Access Compliance Report Public Rights-of-Way (Curb Ramps)

Main Street: UNIVERSITY_DR		Cross Street: N/A		Location:	SW
ADA ID: RPRK211018110608	Ramp Type: Type 4 - Parallel	Initial Pass/Fail: Fail	Overall Compliance: No	Severity Score:	30

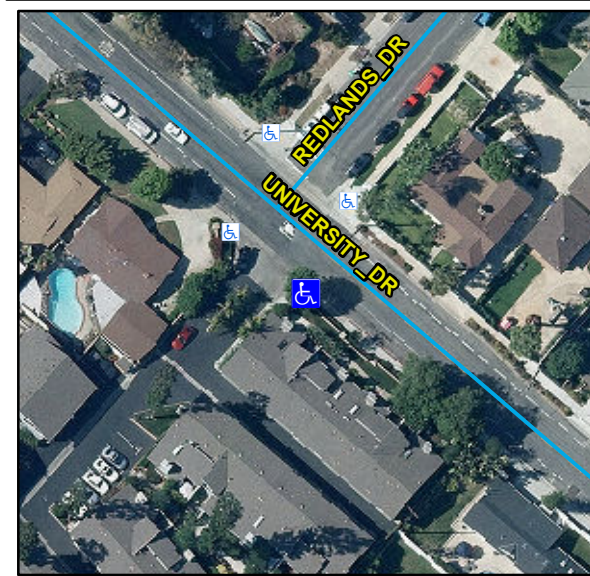
Compliance	Description	Data	Compliance	Description	Data
N/A	Ramp Length LT (in)	74	N/A	Ramp Length RT (in)	114
Yes	Ramp Width LT (in)	57	Yes	Ramp Width RT (in)	50
Yes	Ramp Run Slope LT (%)	2.1	Yes	Ramp Run Slope RT (%)	6.5
No	Ramp Cross Slope LT (%)	7.2	Yes	Ramp Cross Slope RT (%)	0.2
N/A	Landing Present	N/A	N/A	DWS Provided	N/A
N/A	Landing Length (in)	N/A	N/A	DWS Contrast	N/A
N/A	Landing Width (in)	N/A	N/A	DWS Length (in)	N/A
N/A	Landing Run Slope (%)	N/A	N/A	DWS Full Width	N/A
N/A	Landing Cross Slope (%)	N/A		DWS Offset Type	N/A
N/A	Landing Movement Obstructed?	N/A	N/A	DWS Offset Left (in)	N/A
	Landing Movement Type	N/A	N/A	DWS Offset Right (in)	N/A
N/A	Landing Shared	N/A			
N/A	Clear Space	Yes			
N/A	Clear Space To Crosswalk (in)	N/A			
N/A	Marked Crosswalk 1	No	N/A	Marked Crosswalk 2	No
	Crossing 1 Direction	NE		Crossing 2 Direction	NW
	Marked Crosswalk 1 Width (in)	N/A		Marked Crosswalk 2 Width (in)	N/A

N/A	Ramp Inside Crosswalk 1	N/A	N/A	Ramp Inside Crosswalk 2	N/A
	Crossing 1 Slope (%)	3.2		Crossing 2 Slope (%)	1.3
	Crossing 1 Cross Slope (%)	0.2		Crossing 2 Cross Slope (%)	0.2
N/A	Gutter Ponding	N/A	Yes	Curb Slope	3.7
Yes	Gutter Lip Height (in)	0		Road Run Slope (%)	0.8
N/A	Gutter Run Slope (%)	N/A		Road Cross Slope (%)	3
N/A	Gutter Cross Slope (%)	N/A	Yes	Perpendicular Joint Present	Yes
Yes	Overall Surface Condition	Acceptable			
	Cross Gutter Present?	Yes		Spandrel Present?	Yes
	Replace Cross Gutter?	No		Replace Spandrel?	No

Remove & Replace Curb Ramp With Two New Directional Ramps or Equivalent.

R304.5.3, STD 1115
